Intel® 82807AA Video Controller Hub

Specification Update

November 2002

Order Number: 283656-002

Figure 1. Panel Sequencing Diagram

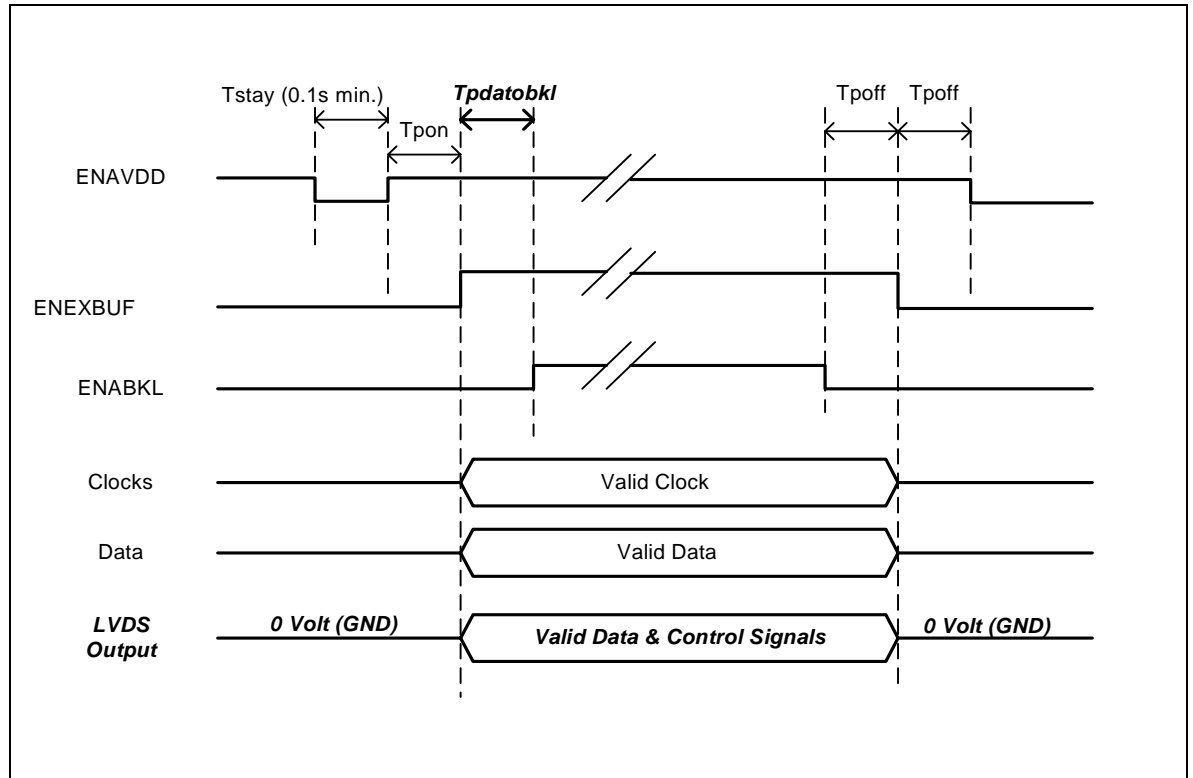
6. Change to Intel 82807AA VCH Panel Sequencing Diagram

In Section 7.4.1.1 (Page 57) Figure 14 should be replaced with:

7. Calculation to Control Registers VR31 and VR32, Power Sequencing

In Figure 1, the Tpdatabkl, Tpon, and Tpooff delays are controlled by the values programmed in VR31 and VR32. These values must comply with the chosen installed panel specification. The actual Tpdatabkl, Tpon, Tpooff, and other delays are based on OSC clock input. These delay value can be programmed to increments of ~1 millisecond. A value of 0 is undefined/implementation specific and should be avoided by programmers. Refer to the latest datasheet and specification update for more information on registers VR31 and V32 of the VCH.

Figure 2. LP and DE With respect to H_TRP

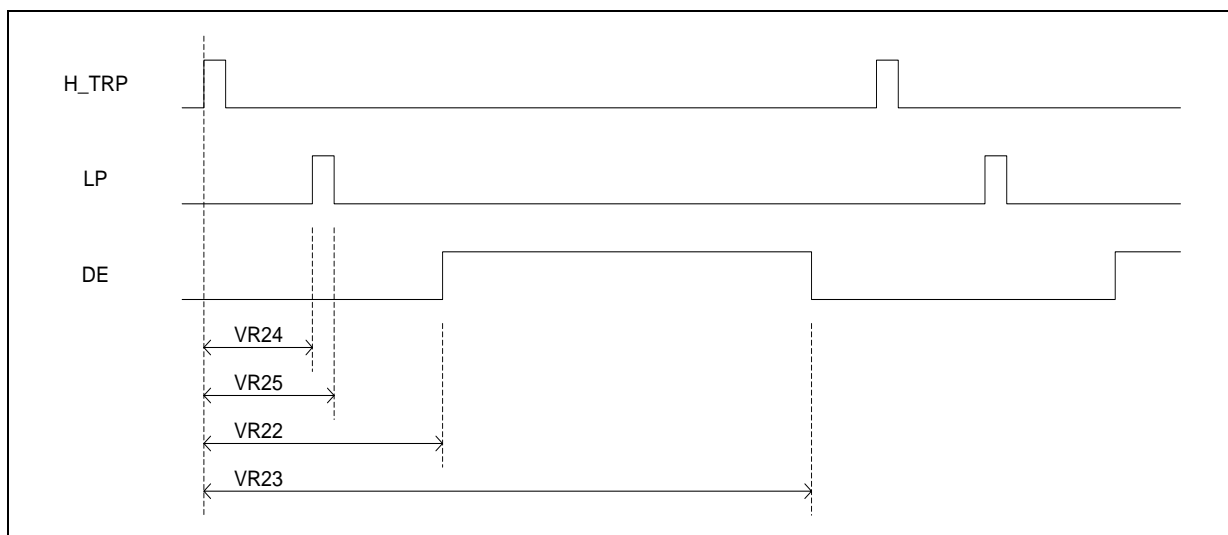
1. Correct Flat Panel Timing Diagram

In Section 8.1.1.1 (Page 52) Figure 10 should be replaced with:
